**Addendum No. 3**

**Final Environmental Impact Report  
for Metro Gold Line Foothill Extension - Azusa  
to Montclair (SCH 2010121069)**

**Evaluating Minor Design Changes of the Project  
Azusa to Montclair**

Metro Gold Line Foothill Extension Construction Authority  
March 2016

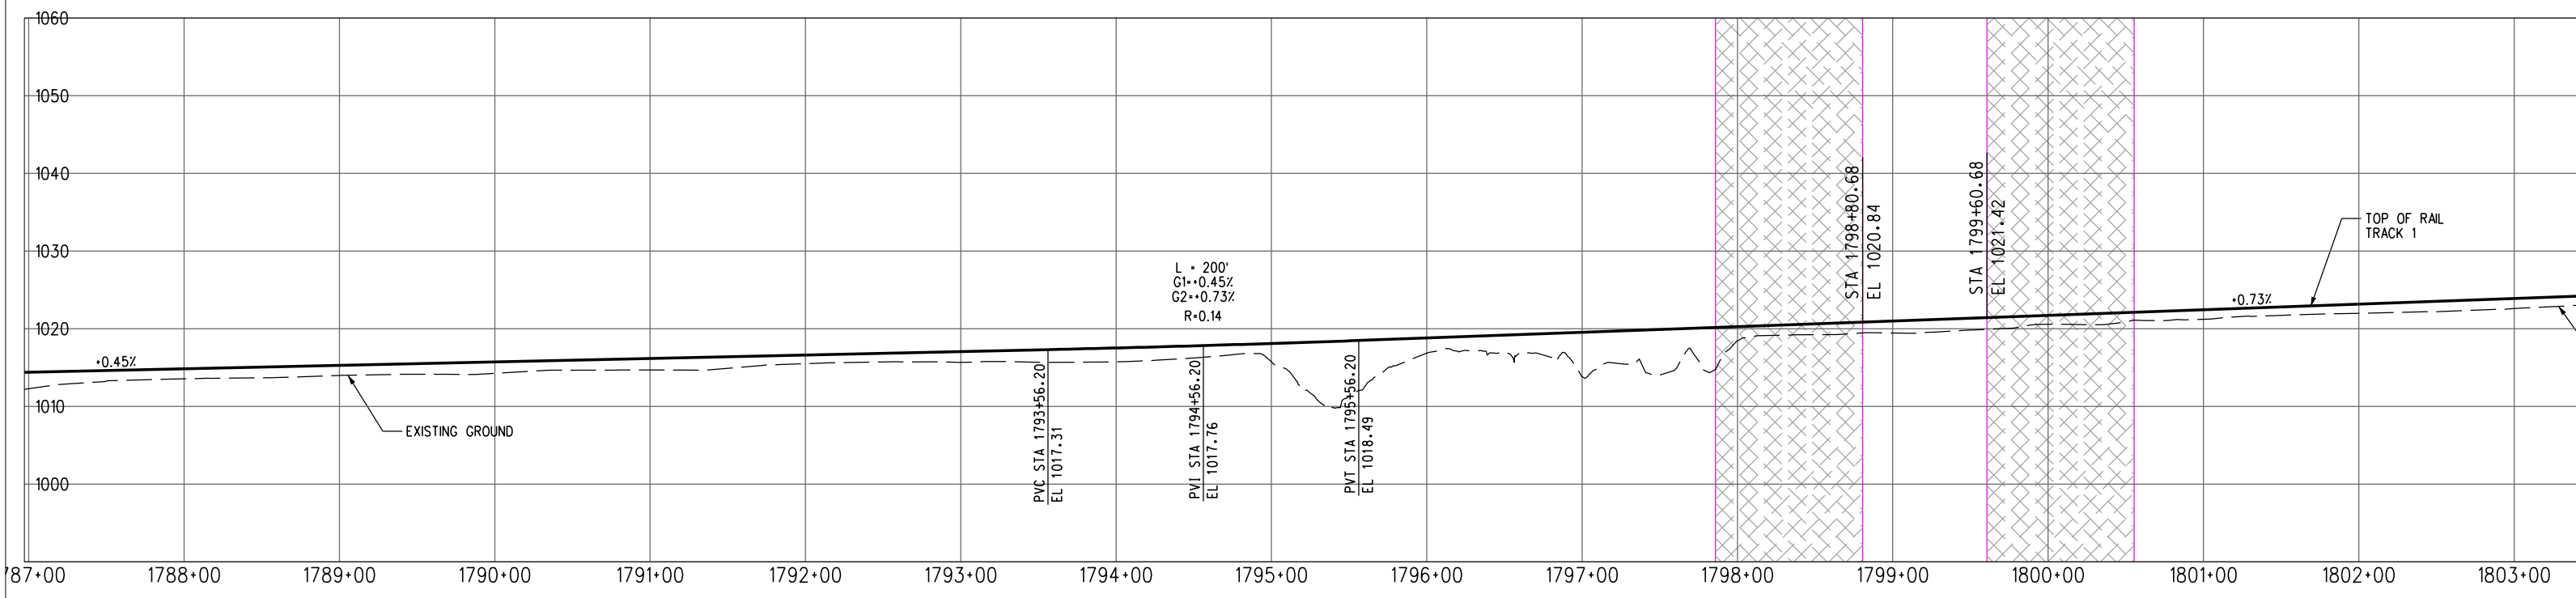
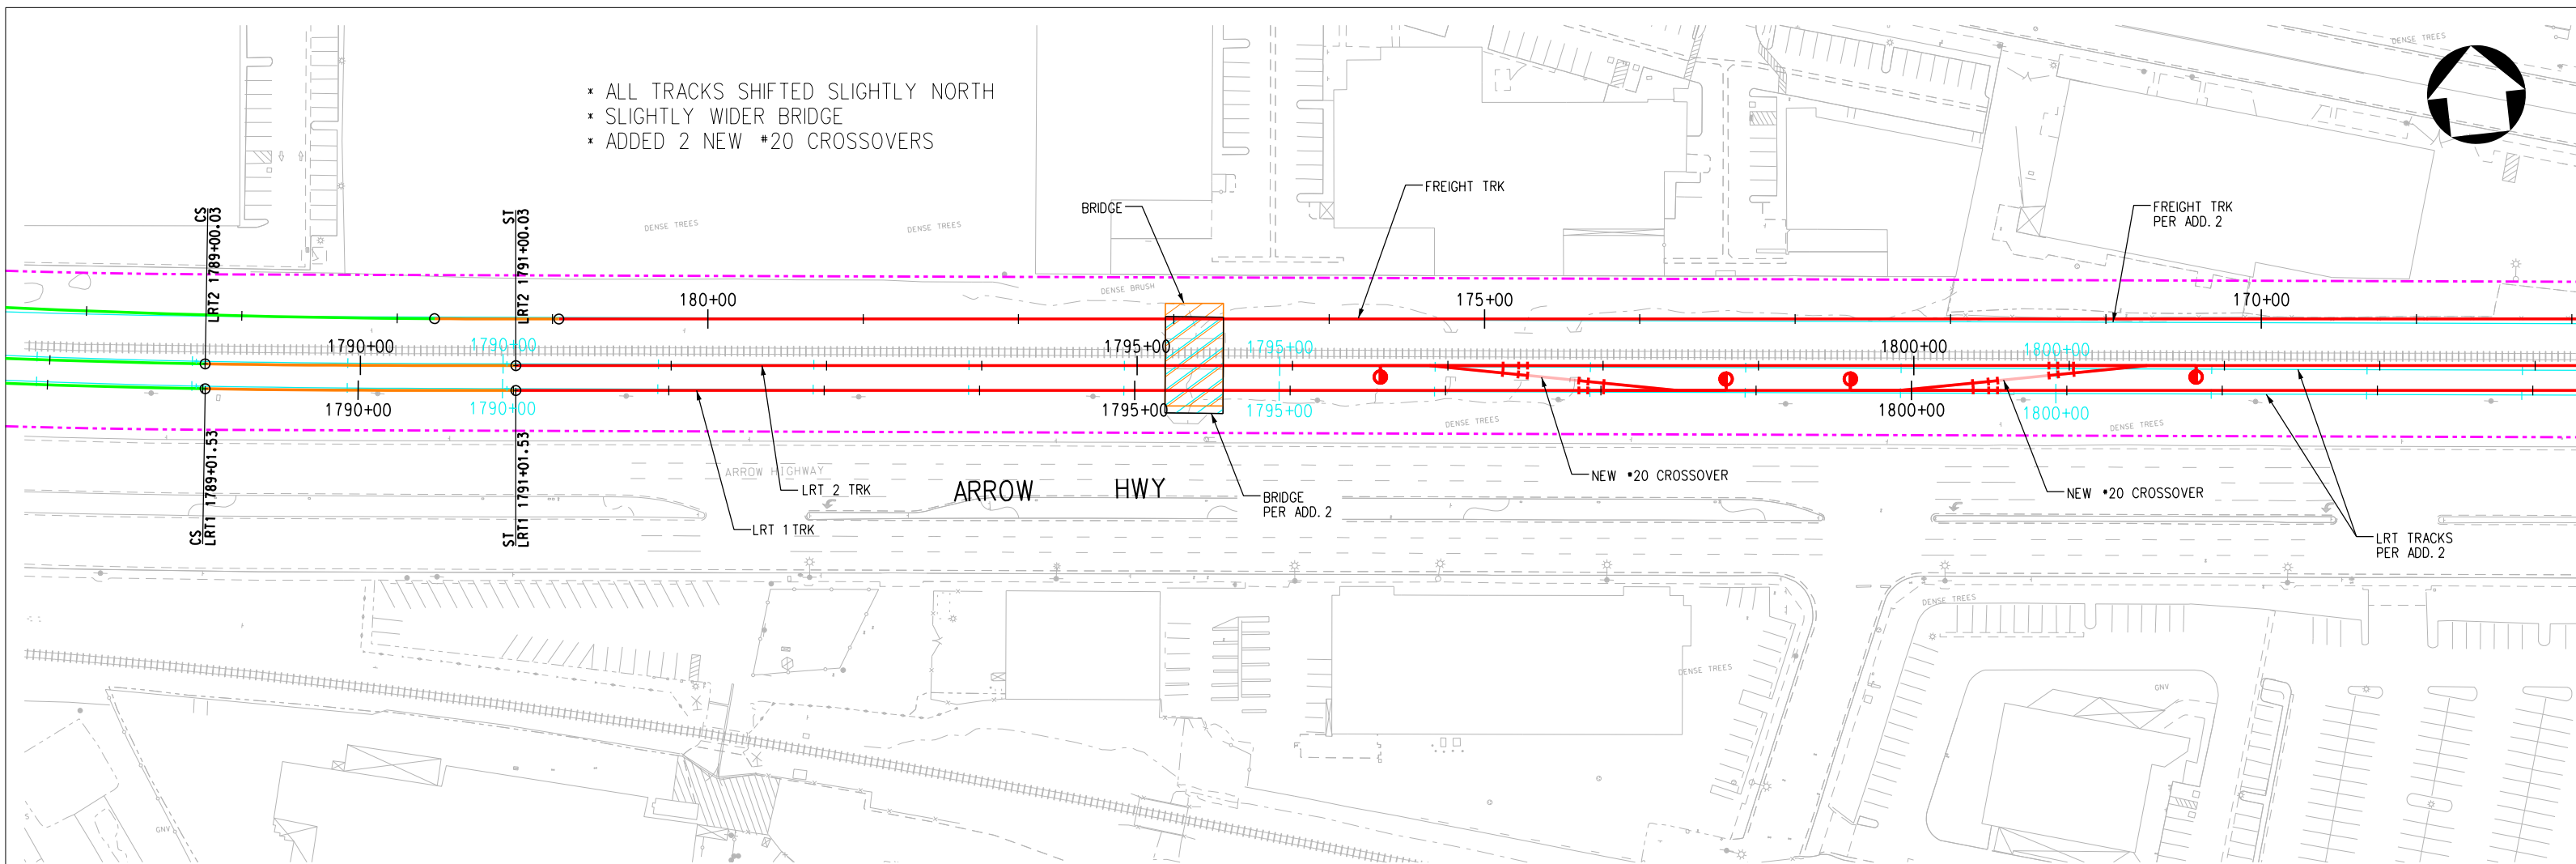
- \* ALL TRACKS SHIFTED SLIGHTLY NORTH
- \* SLIGHTLY WIDER BRIDGE
- \* ADDED 2 NEW #20 CROSSOVERS

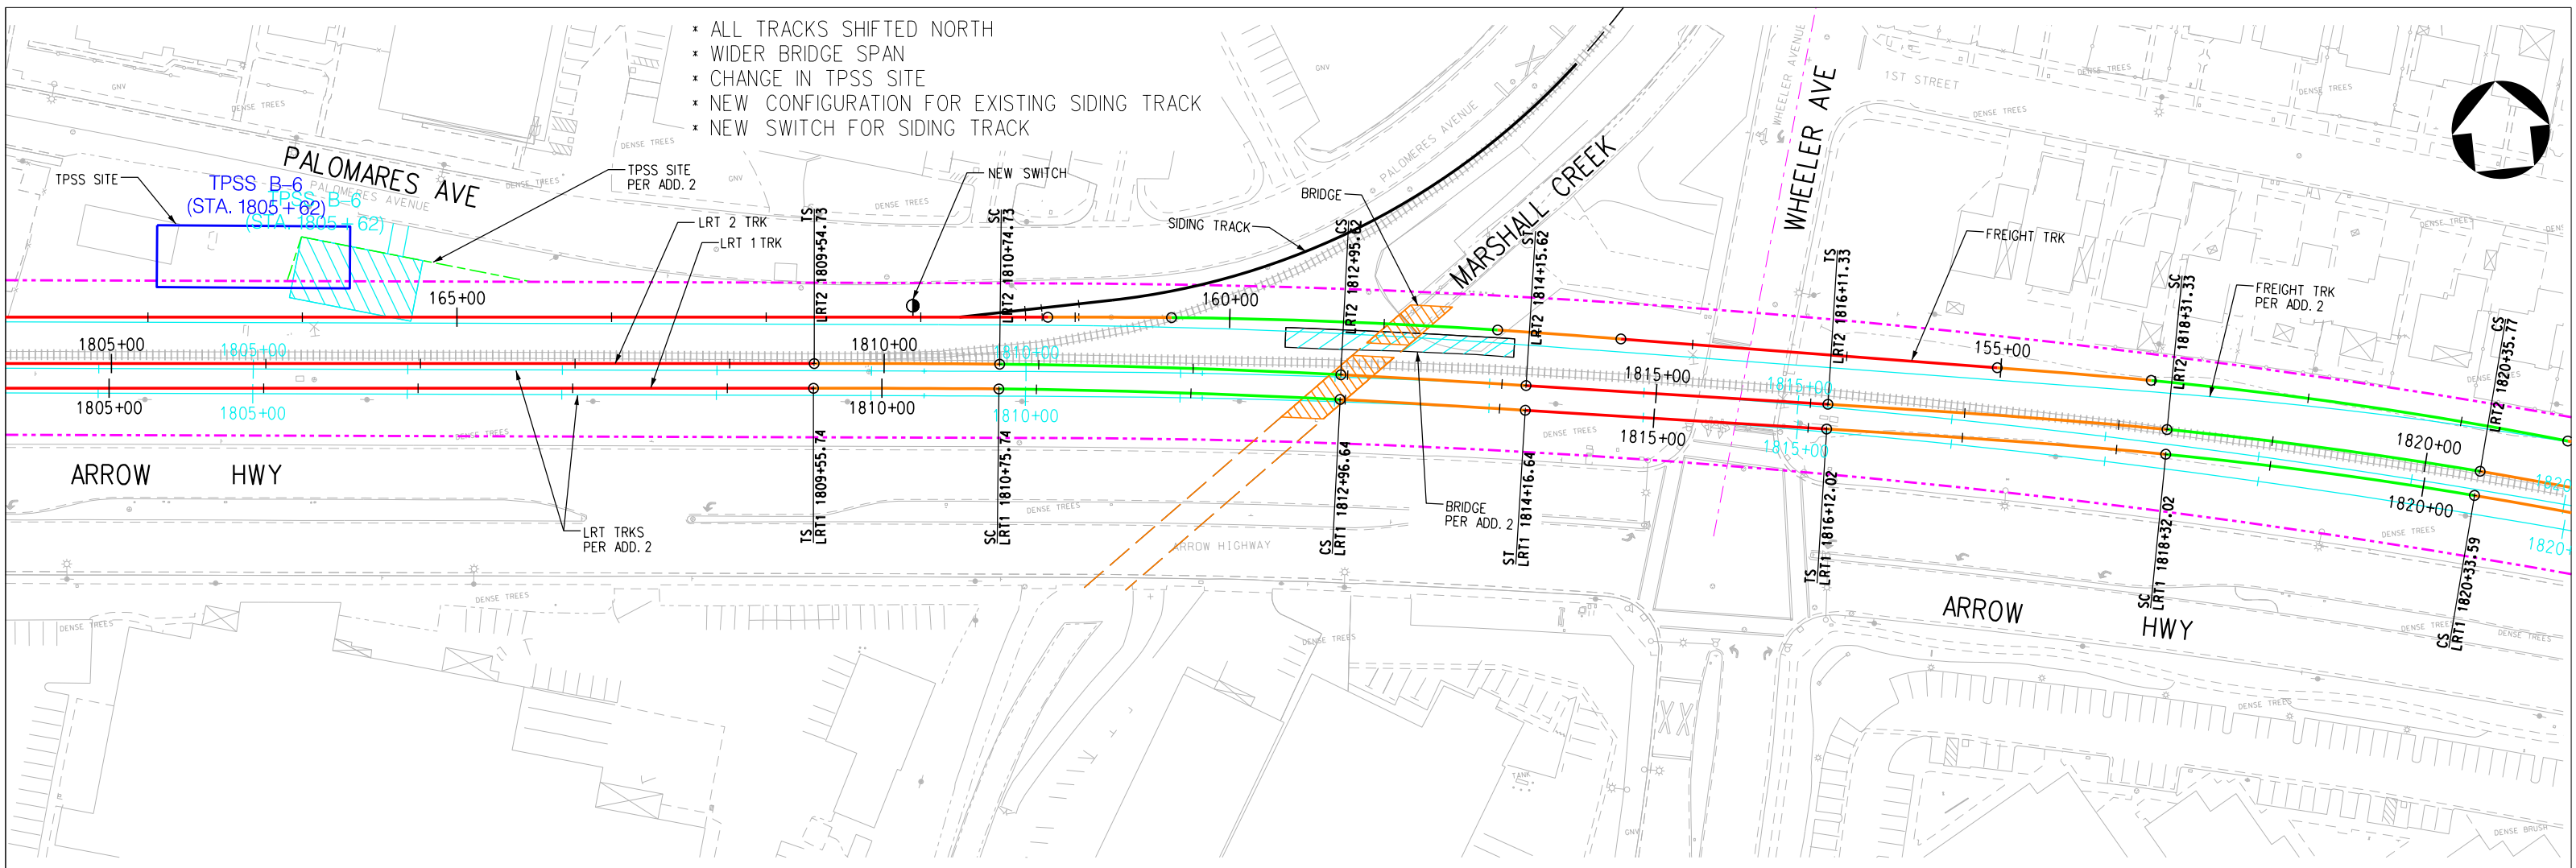
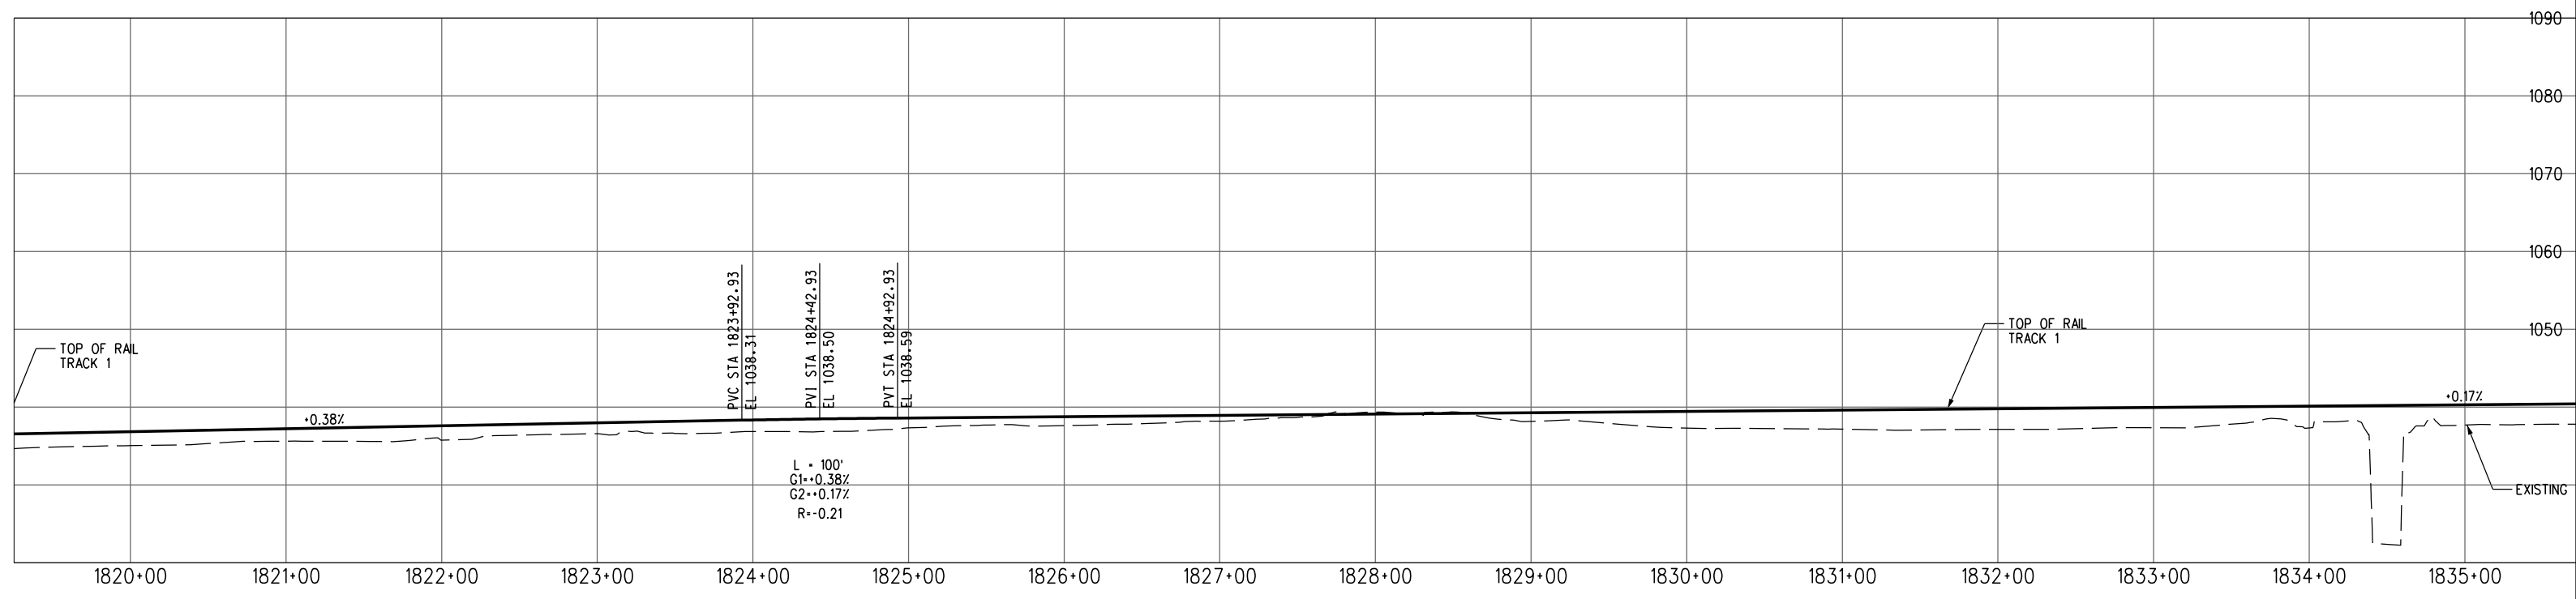
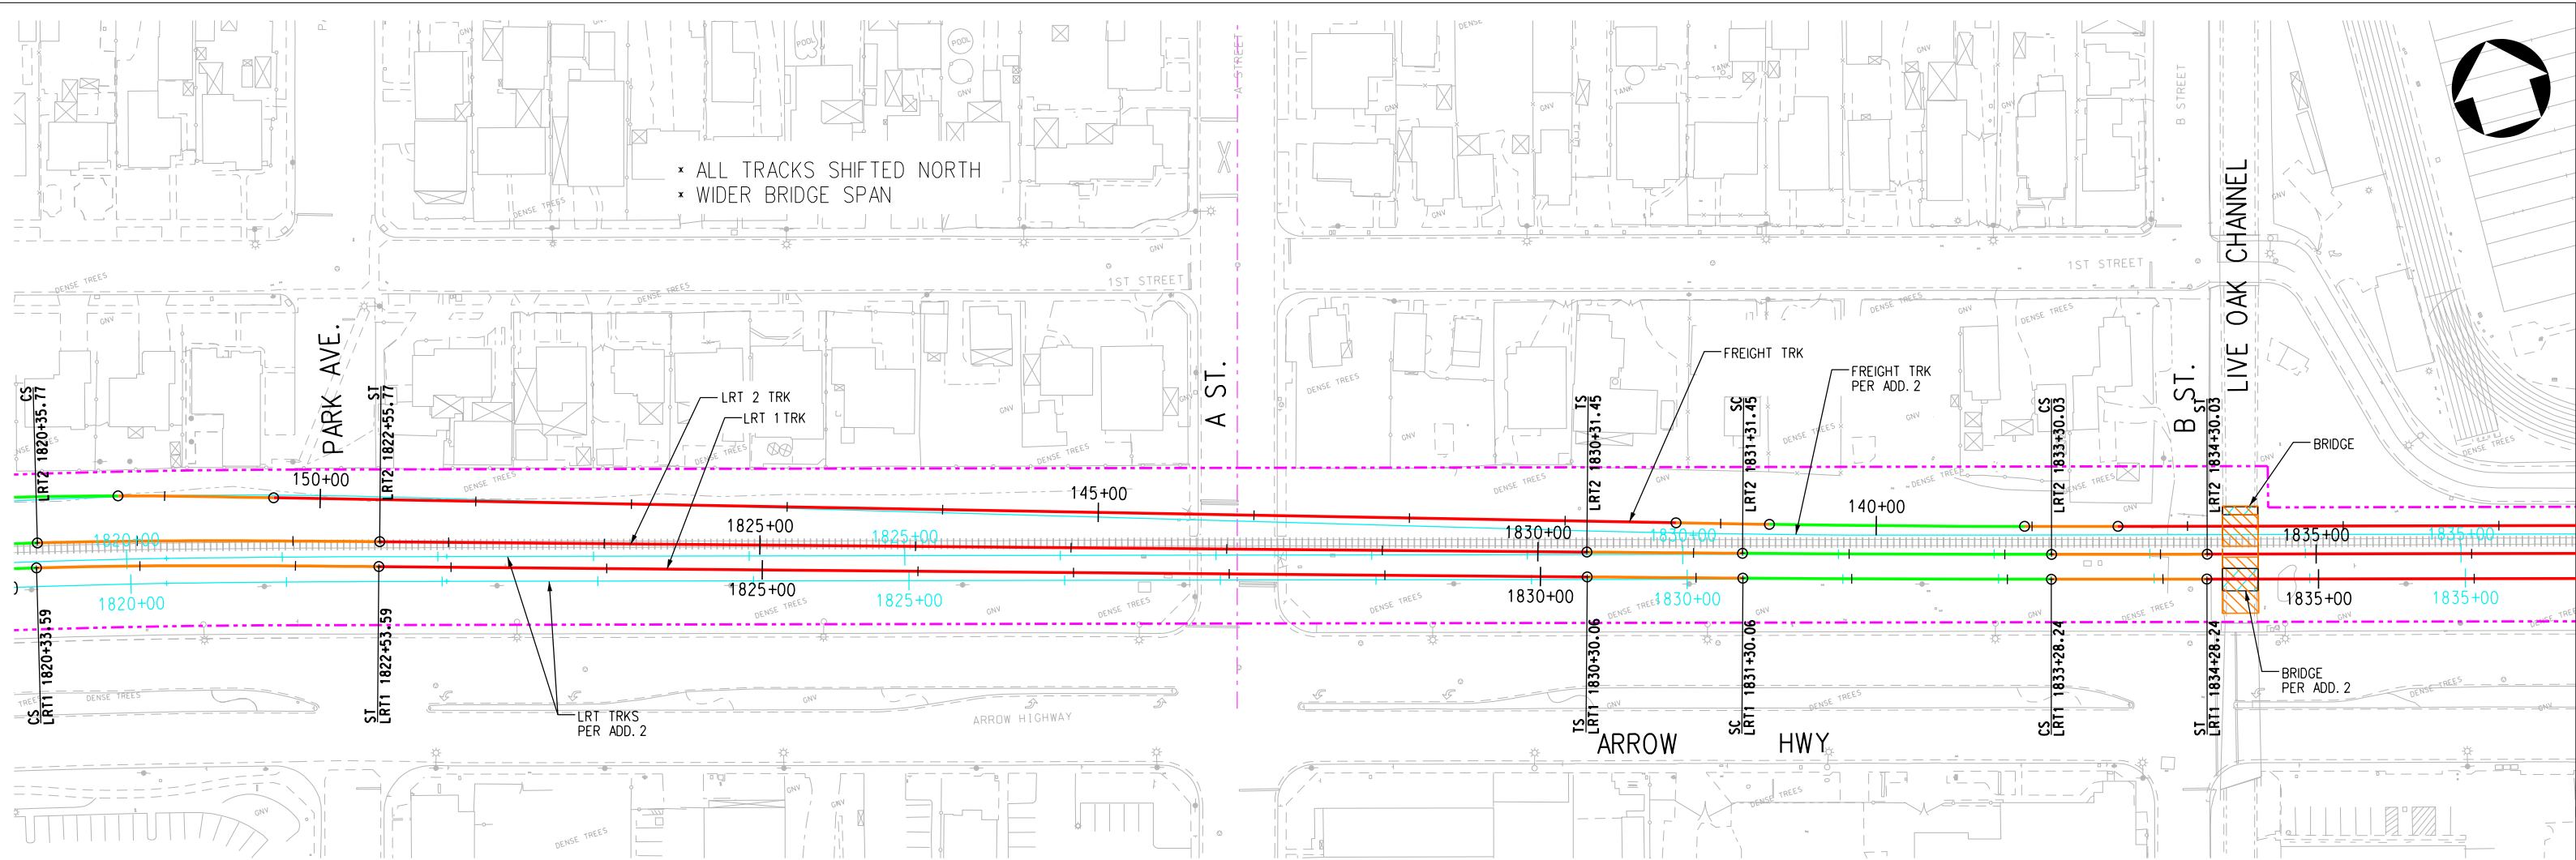
- \* ALL TRACKS SHIFTED NORTH
- \* WIDER BRIDGE SPAN
- \* CHANGE IN TPSS SITE
- \* NEW CONFIGURATION FOR EXISTING SIDING TRACK
- \* NEW SWITCH FOR SIDING TRACK
